Ogdensburg City School District

2023 Capital Outlay Project

Bus Drive Pavement Replacement

Change Order Number: 1-03

Cost Proposal BC03 from Contractor dated 7/25/23 Controt Drawings L310, L320, L330

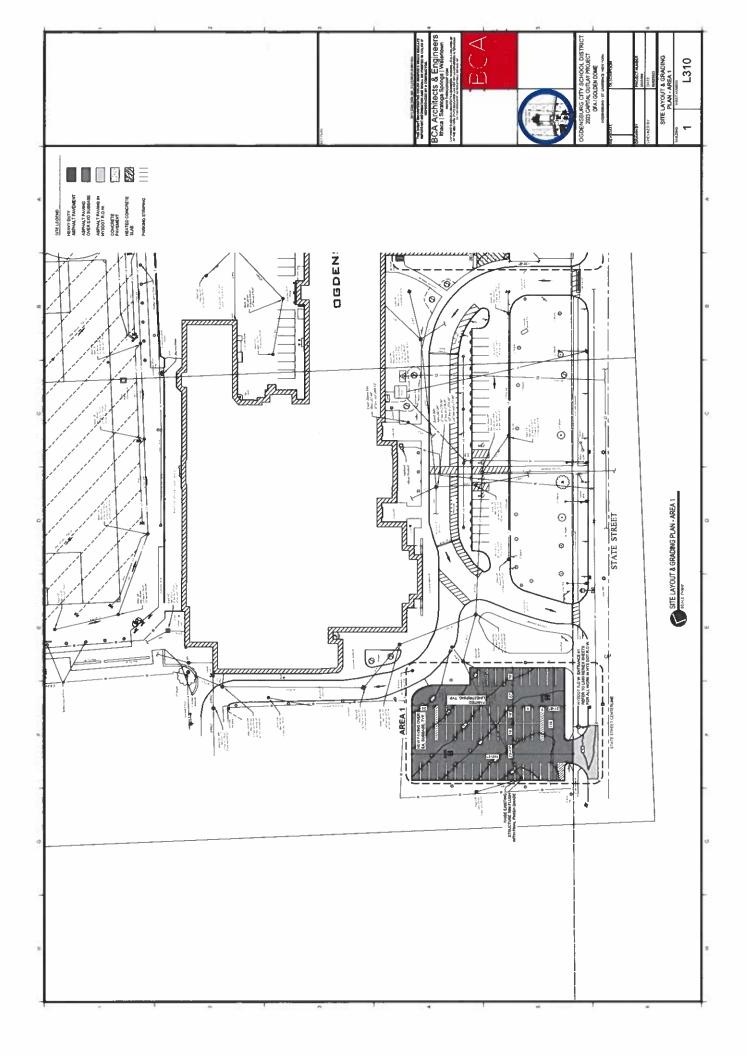
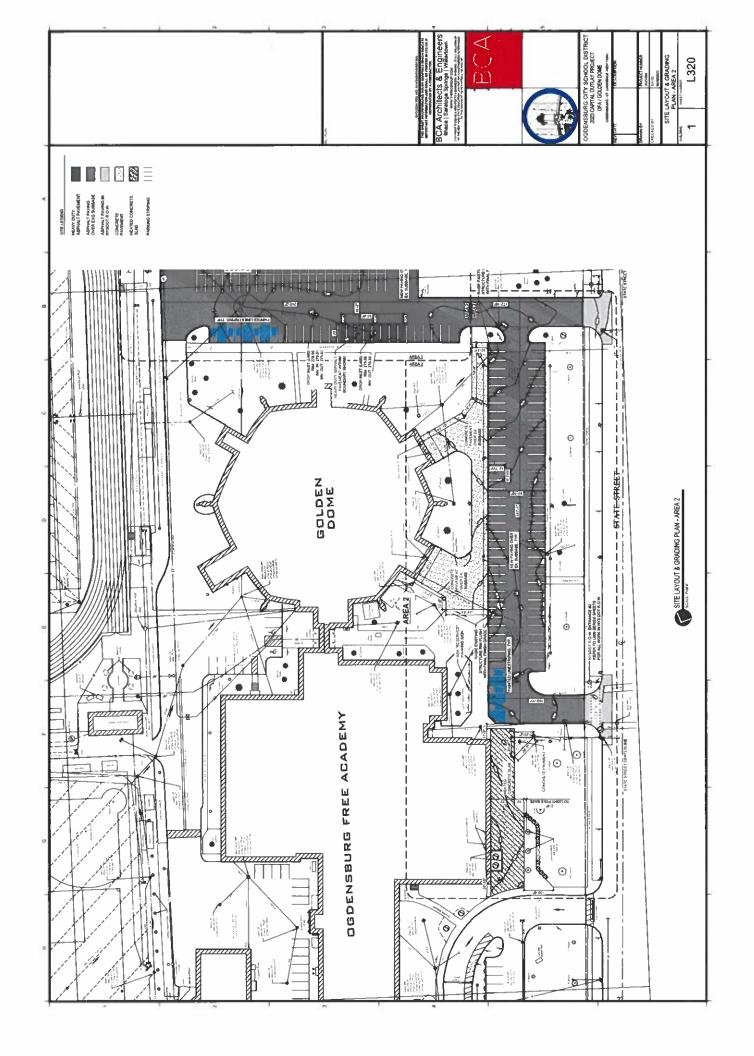
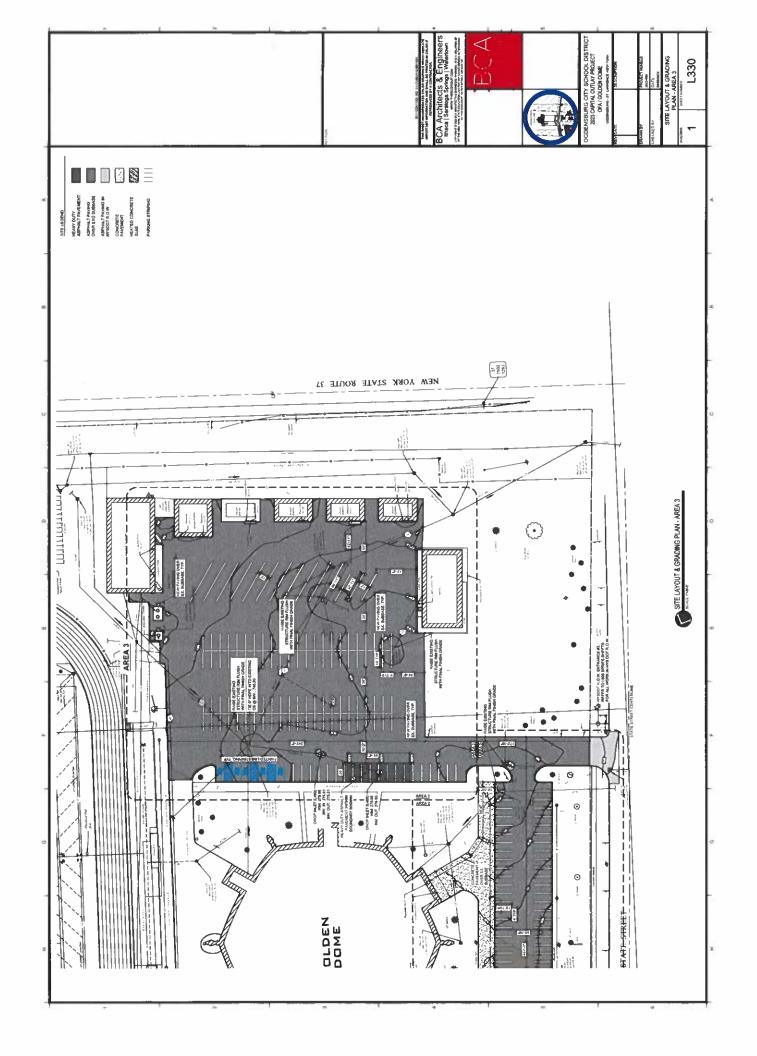
Add to provide all labor, materials, and equipment to replace deteriorated asphalt at the bus drive behind the Golden Dome in accordance with unit pricing as per the Form of Proposal for Contract No. 1 - General Construction.

Area 1: Bus Drive Area Mill and repave 8,702SF @ \$10/SF = \$87,020
